# CITY OF ALBUQUERQUE

Shawn Biazar SBS Construction and Engineering, LLC 10209 Snowflake Ct. NW Albuquerque, NM 87114					
	RE:	142 40 <sup>th</sup> Street SW Grading & Drainage Plan Engineer's Stamp Date: 02/21/20 Hydrology File: K12D037				
	Dear Mr. Biazar:					
PO Box 1293	Based upon the information provided in your submittal received 02/28/2020, the Grading & Drainage Plan <b>is not</b> approved for Building Permit and Grading Permit. The following comments need to be addressed for approval of the above referenced project:					
Albuquerque	1.	This project is an administrative site review. Therefore you should have paid \$310 for the Hydrology review. Only \$150 of this was paid at the time of submittal, therefore the remainder of <b>\$160</b> is due at the time of the resubmittal.				
NM 87103	2.	Please provide existing topographic survey information with existing grades on the site. Without this information, it is difficult to tell what is going on with the site. Also provide the Benchmark information (location, description and elevation) for the survey contour information provided.

142 40TH STREET, SW
GRADING AND DRAINAGE PLAN

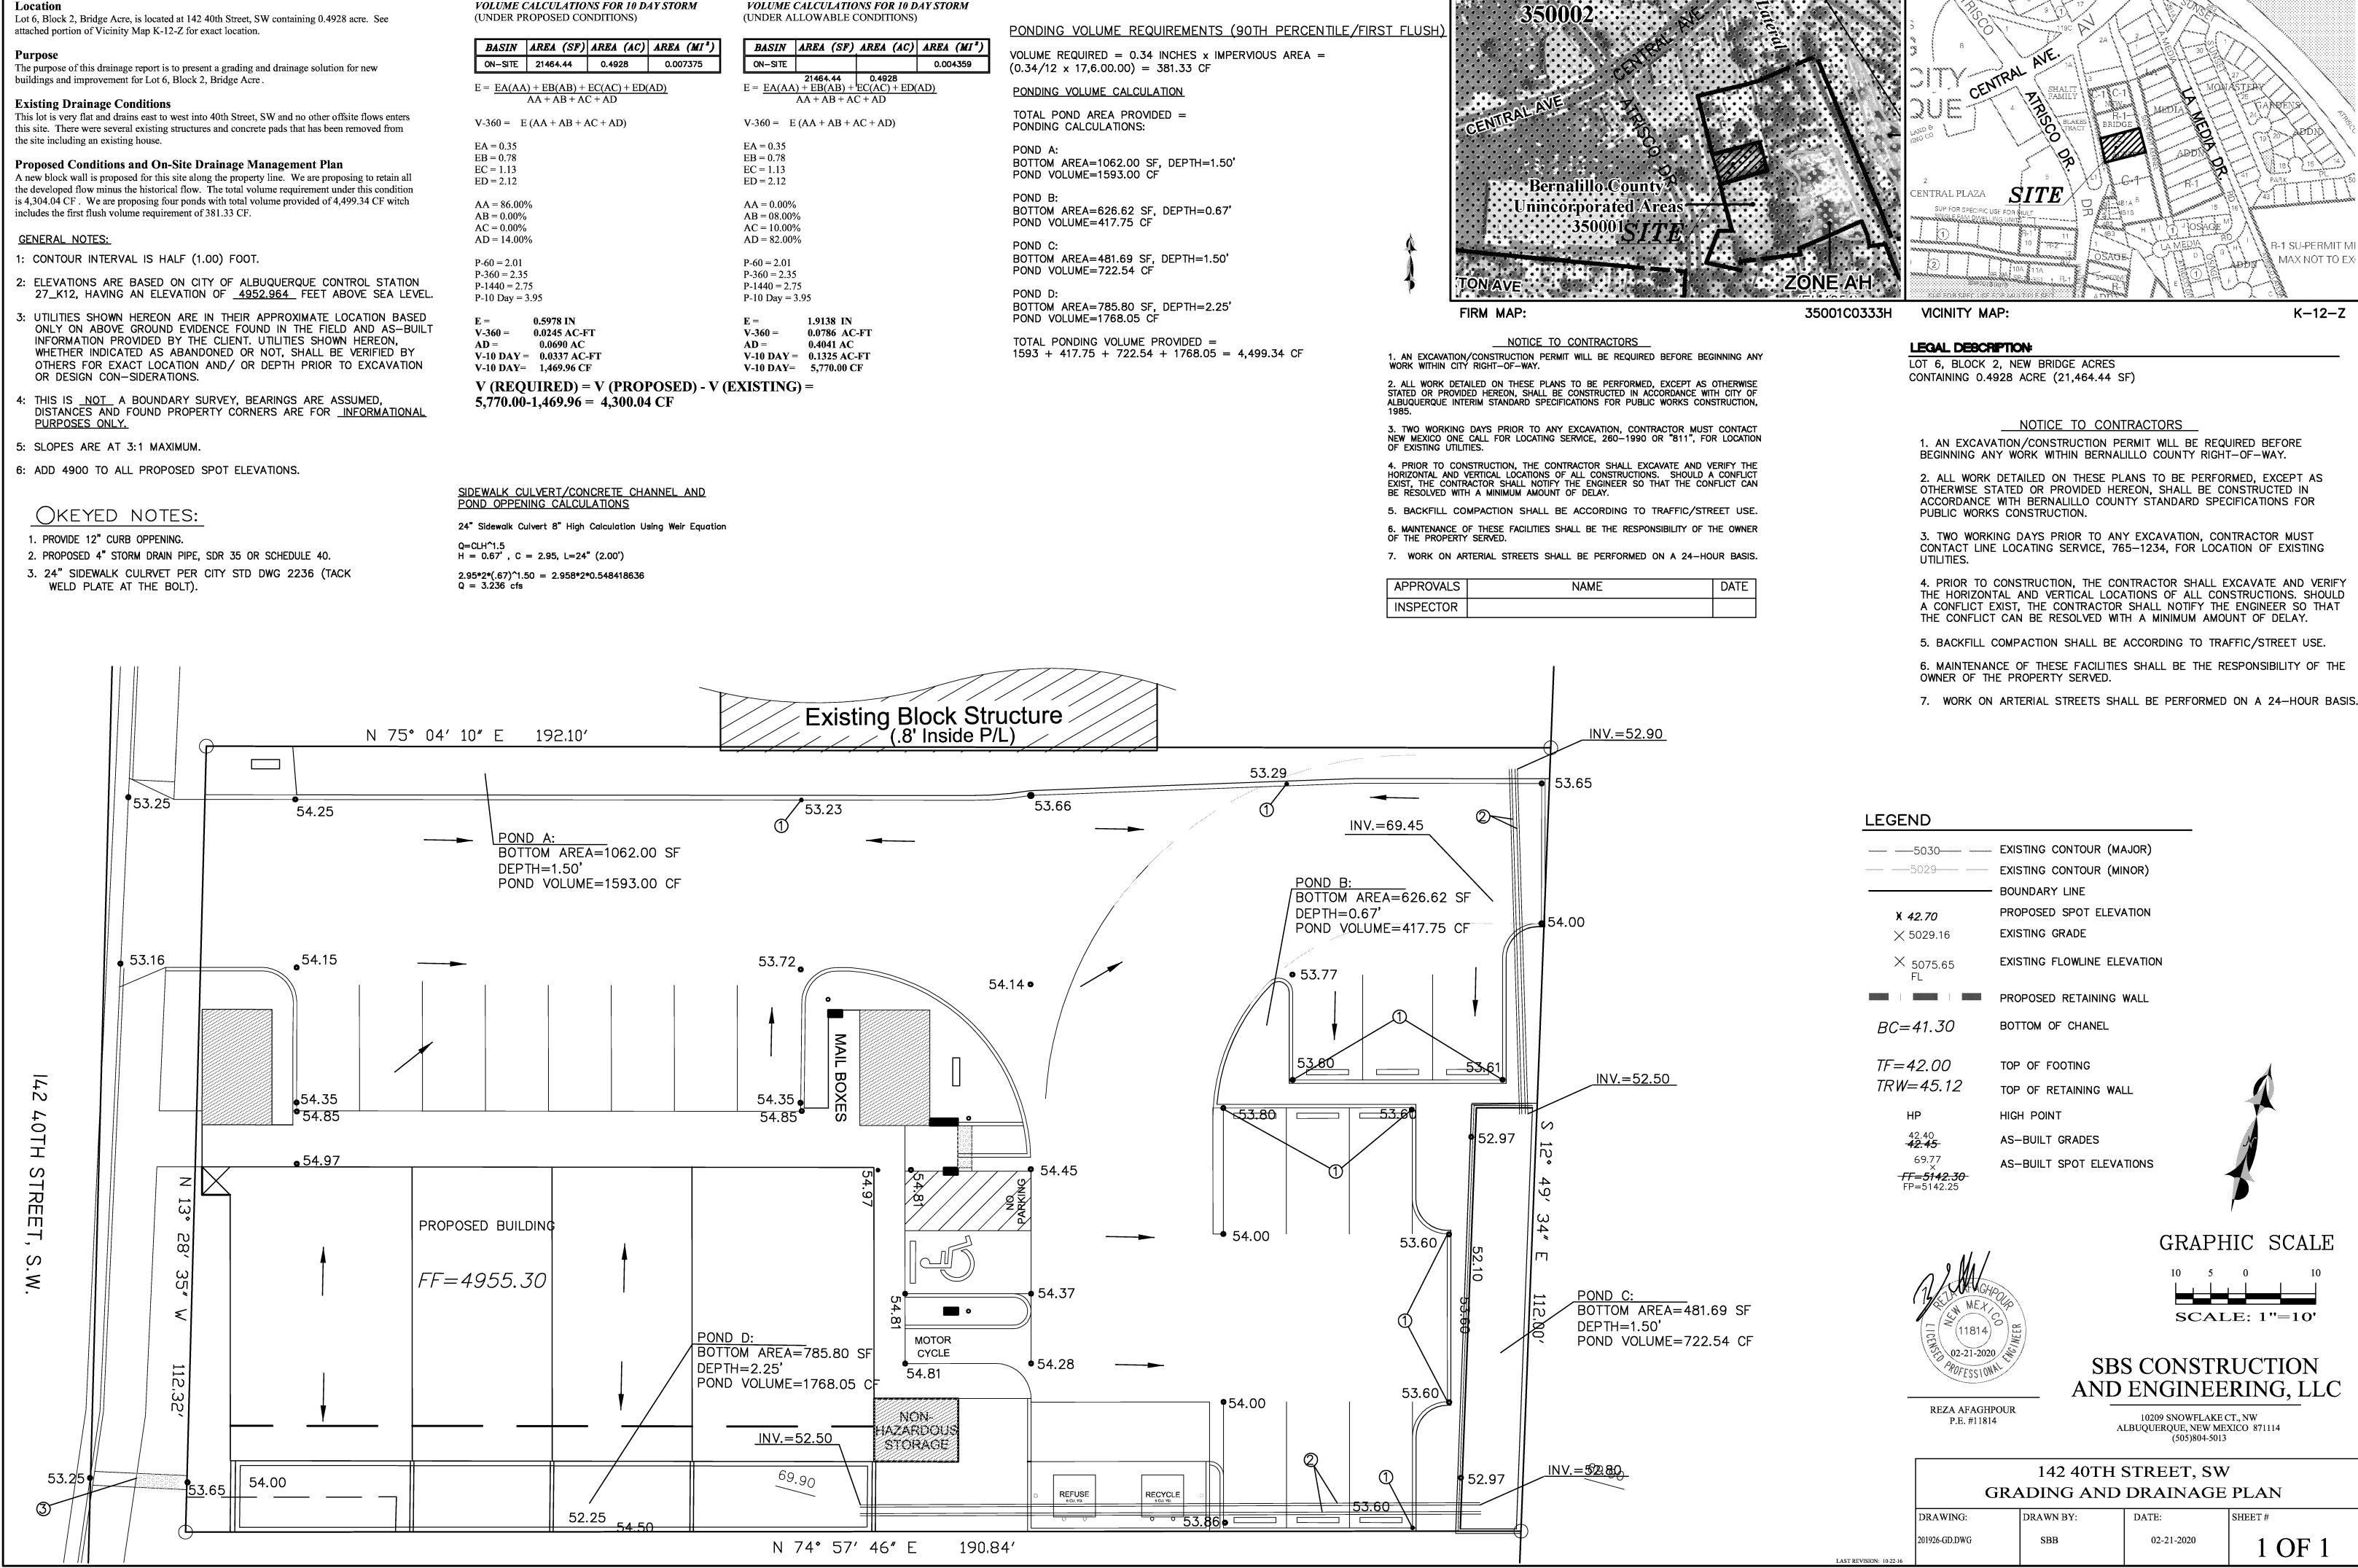
www.cabq.gov	3.	There is a proposed retention pond right up against the existing structure that is over the property line. How is this structure being protected? Is the property Owner taking the liability of damaging this structure?

4.	There are several errors in the G&D with missing line work, extra line work, line work not matching the Legend, or line work not labeled. There are several texts with line work under them which makes it hard to read. There are two hatched areas not labeled. Please clean up the G&D.

5.	<ul> <li>Since this site is in the Valley region, please follow Chapter 22 Section 5.G (Flat Grading Scheme). The following conditions must be applied to the site:</li> <li>The maximum percent impervious of the lot and the contributing area may not be greater than 45%.</li> <li>Pad elevation shall be a minimum of one (1) foot above the 100 year 10-day stormwater surface elevation.</li> </ul>

- The flow between the front yard and back yard cannot be obstructed. The stormwater must be allowed to equalize to the same level between the front yard and back yard.

- A permanent perimeter wall or barrier around the development is required to contain the 100 year 24 hour storm developed runoff.
- The high point of the street should be four inches above the 100 year 10-day stormwater surface elevation.

- 6. In your narrative and drainage calculations, it talks about historical flows. This is not allowed by the DPM. Please follow the Flat Grading Scheme outlined in the DPM and in comment #4.

- 7. Since this is in the Valley region and will not be allowed to discharge into 40<sup>th</sup> Street, please remove the proposed sidewalk culvert, calculations, and the SO-19 notes.

- 8. Provide sections through each retention pond. This should show proposed retaining walls, the retention volume water surface elevation, property/ROW lines, existing and proposed grades. In accordance with DPM Ch.22, section 5 part B, grading and wall construction near the property line may not endanger adjacent property or constrain its use.

- 9. If the proposed retaining wall will create such an encroachment, written agreement from both landowners must be provided for such work. Written permission must include: signature of the property owner or owners representative, statement that undersigned is the owner or authorized representative, permission to construct the encroachment with a brief description of the encroachment.
